**CORRESPONDENCE COVER SHEET  
WASTE PERMITS DIVISION  
TEXAS COMMISSION ON ENVIRONMENTAL QUALITY**

Date: October 20, 2022  
 Facility Name: Twin Oaks Power Station CCR Landfill  
 Permit or Registration No.: CCR112

**RE: Response to TCEQ Technical NOD 2 Correspondence Dated September 22, 2022  
Twin Oaks Power Station Coal Combustion Residuals Landfill  
Major Oak Power, LLC  
Bremond (Robertson County), Texas  
CCR Registration No. CCR112  
TCEQ SWR No. 37677; EPA ID No. TXD987997988  
Tracking No. 27247279; RN100226570/CN604670034**

**GROUNDWATER CONTOUR MAP**  
 ← WATER LEVELS MEASURED (3/23/2016) →

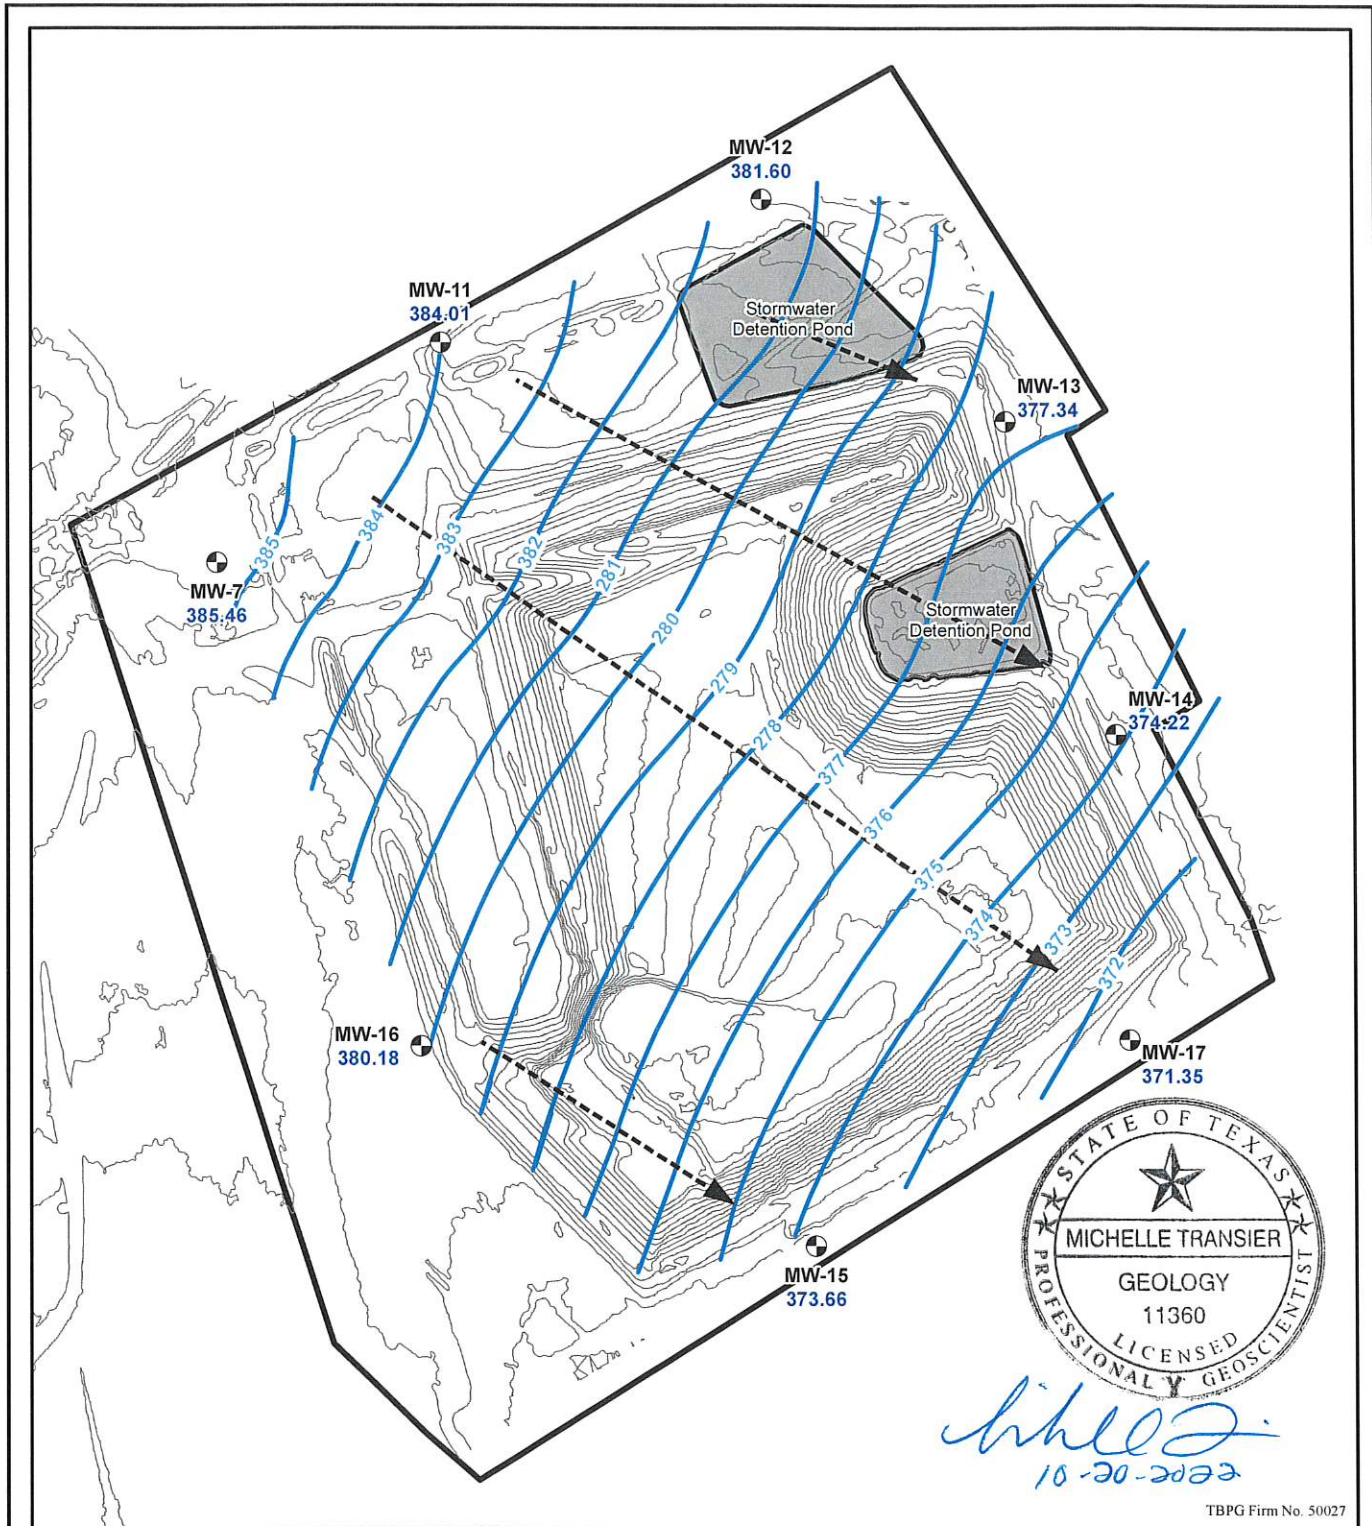
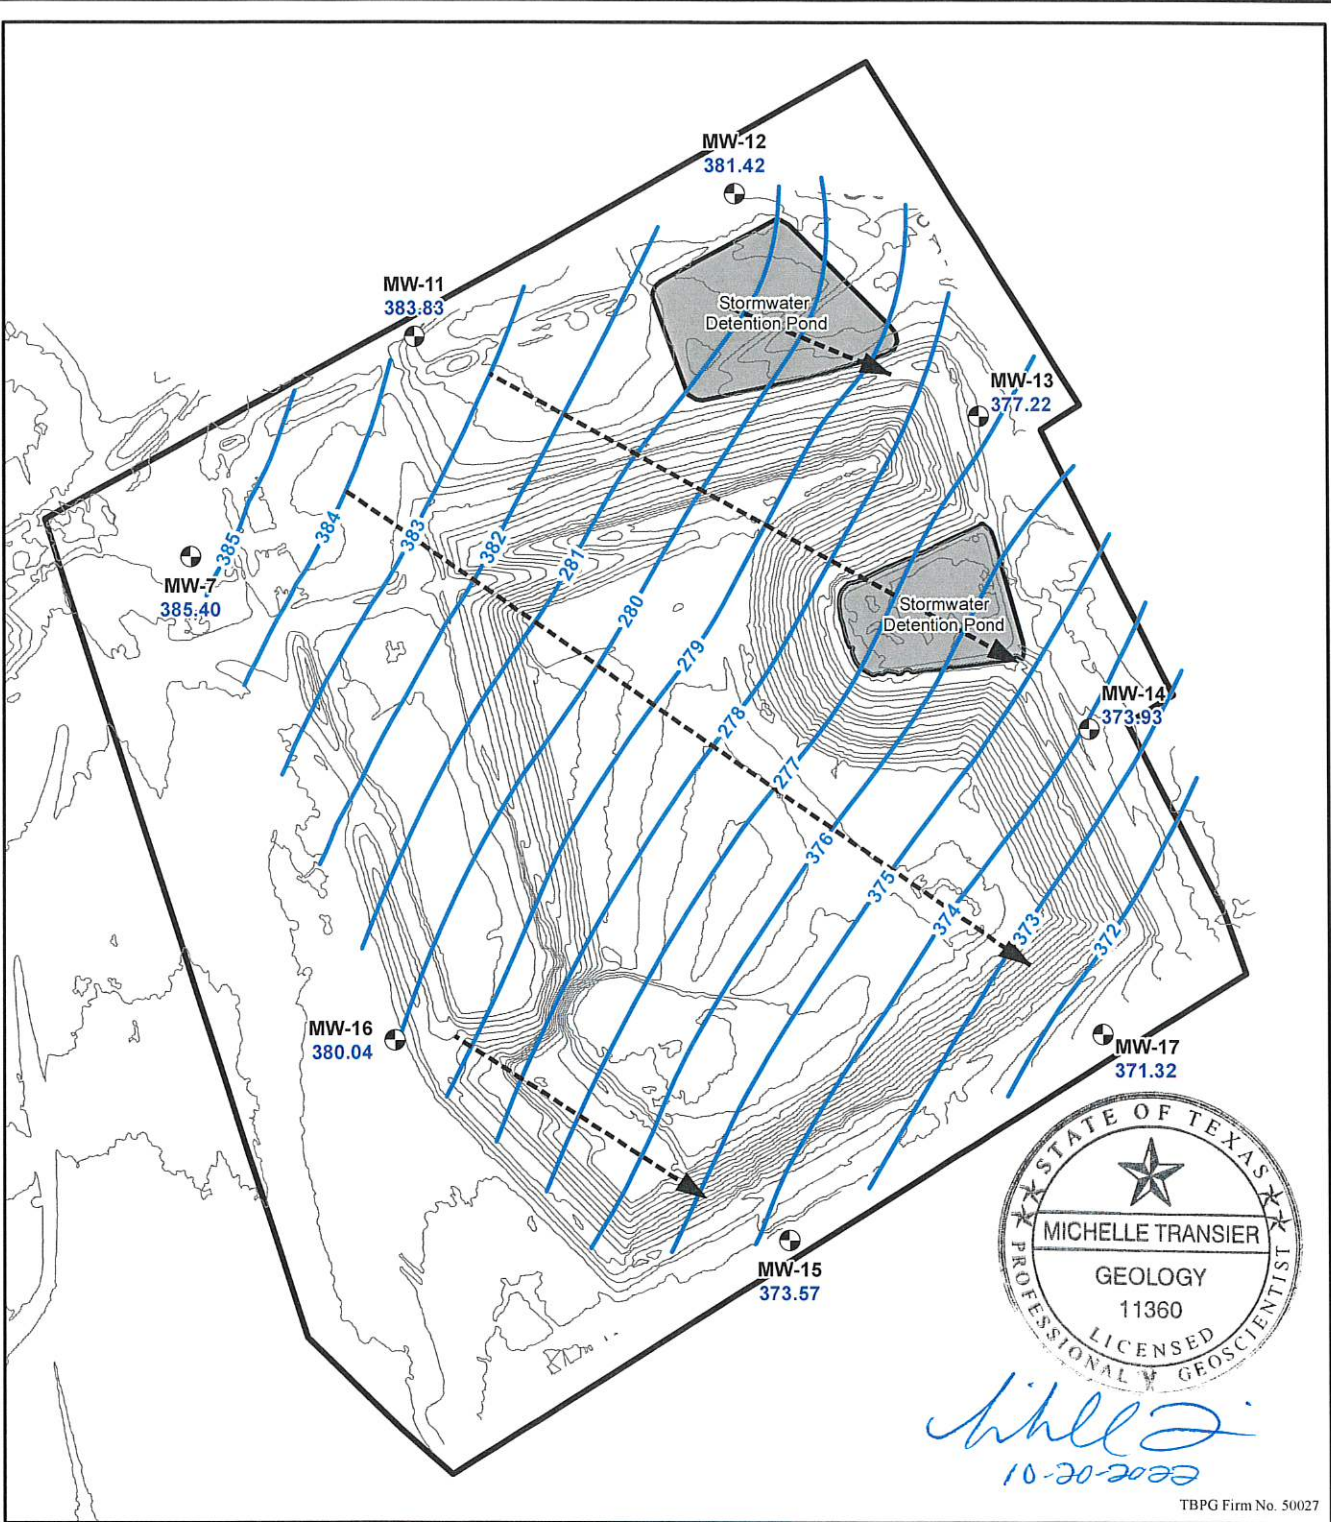
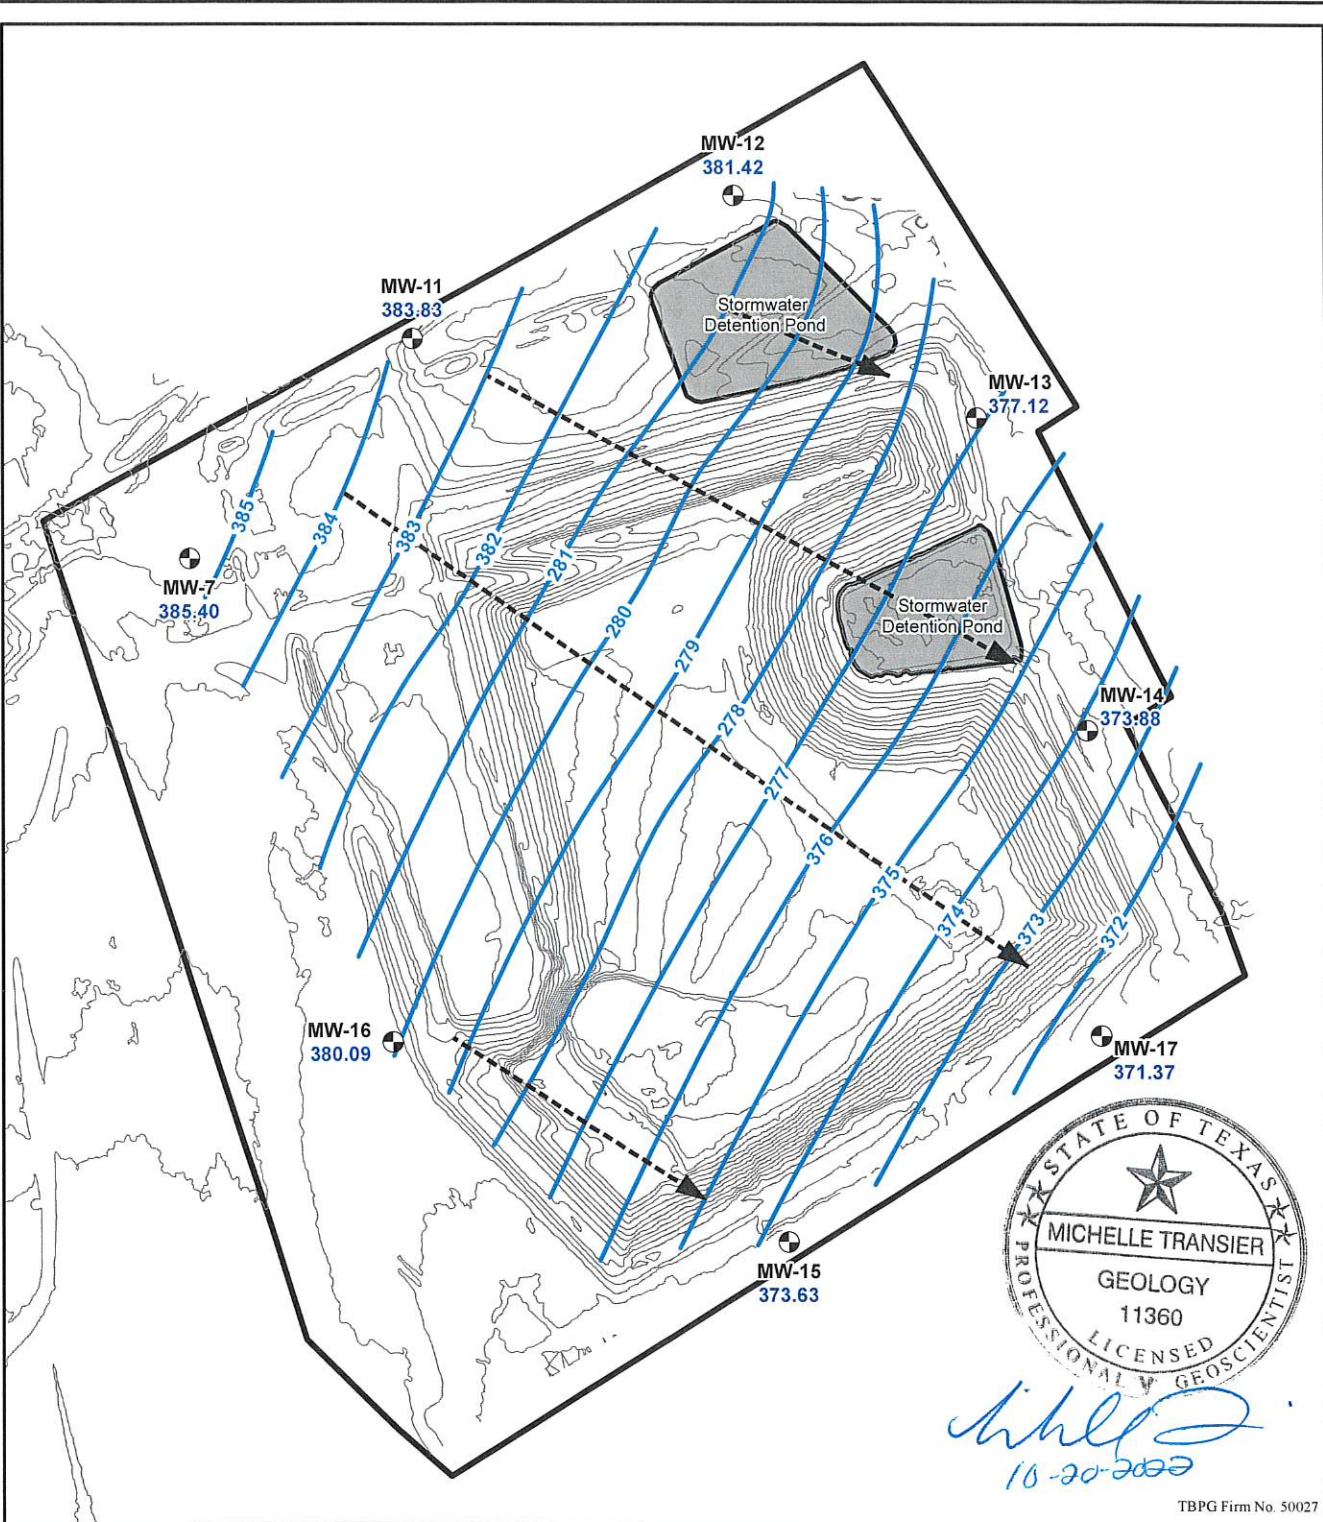
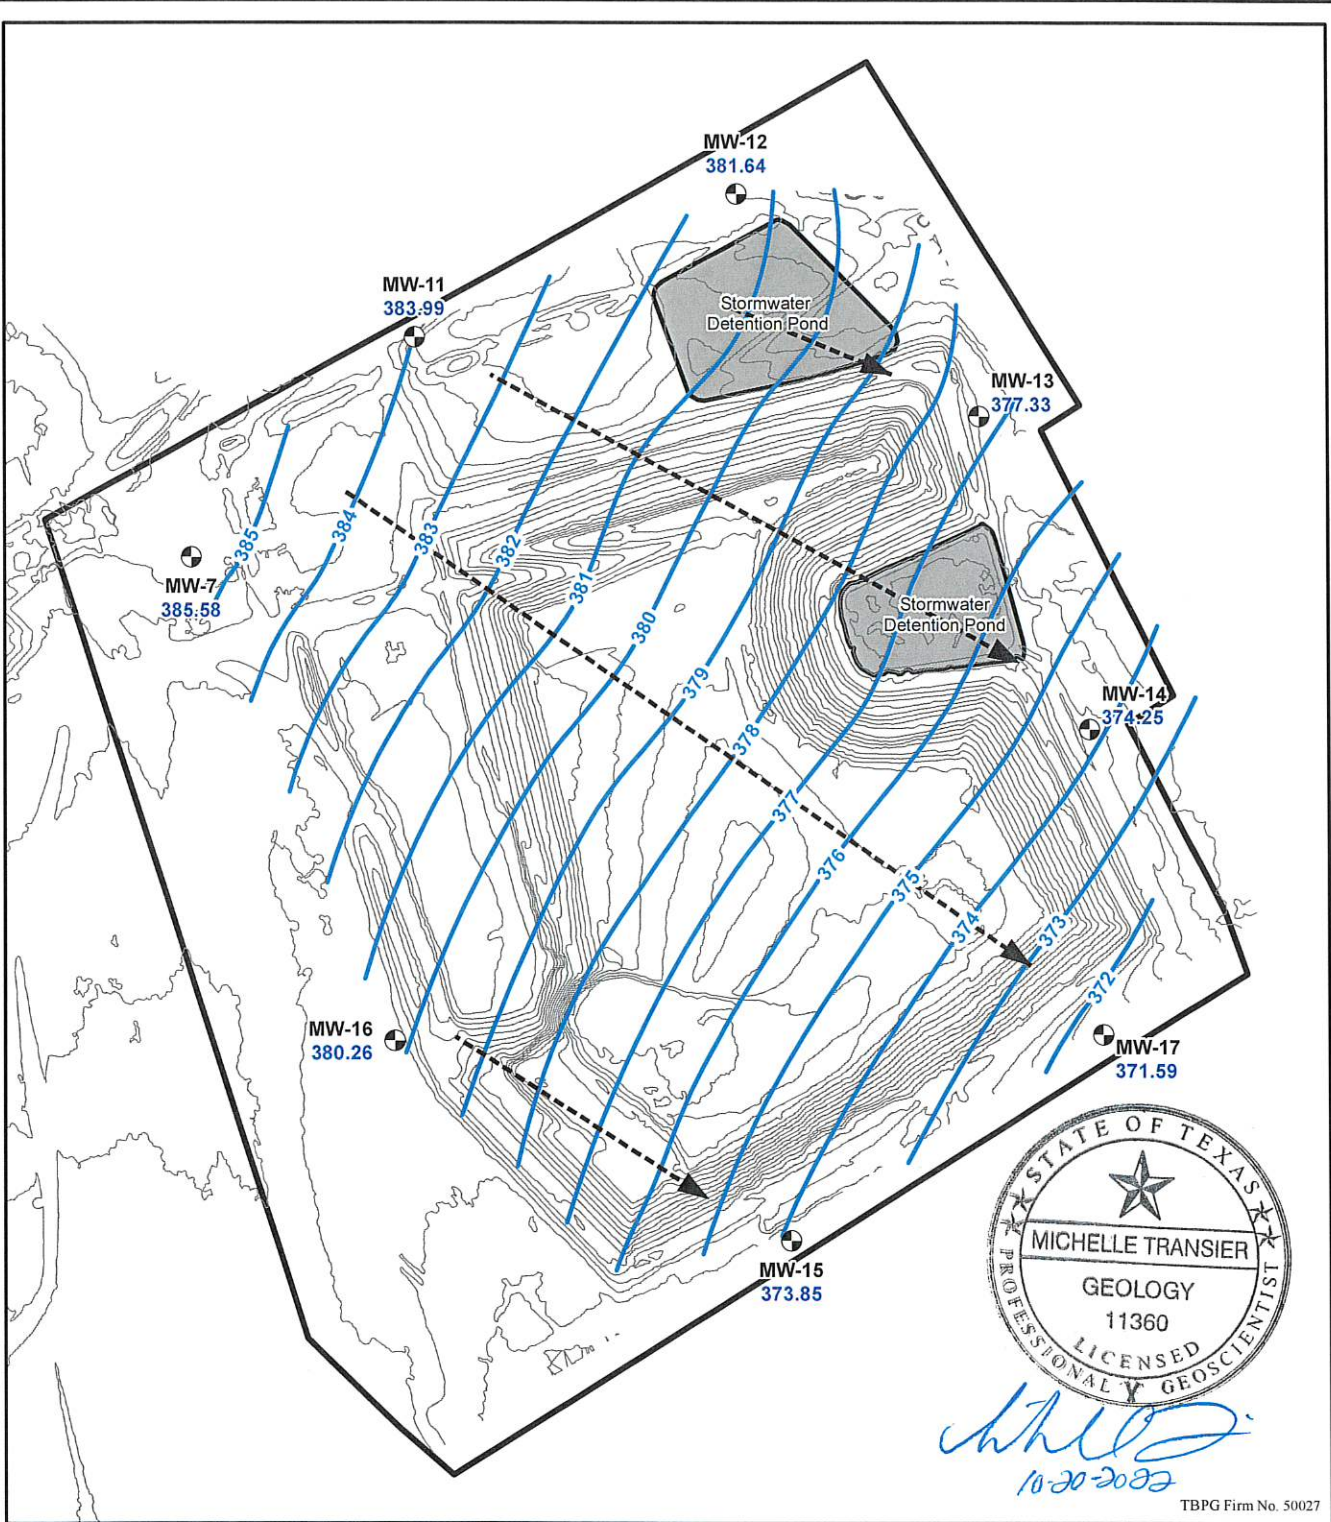
*Seal all of the groundwater contour maps and include the Firm Number.*

All groundwater contour maps have been signed and sealed by a licensed professional geoscientist in the State of Texas. The signed/sealed maps are attached herein.
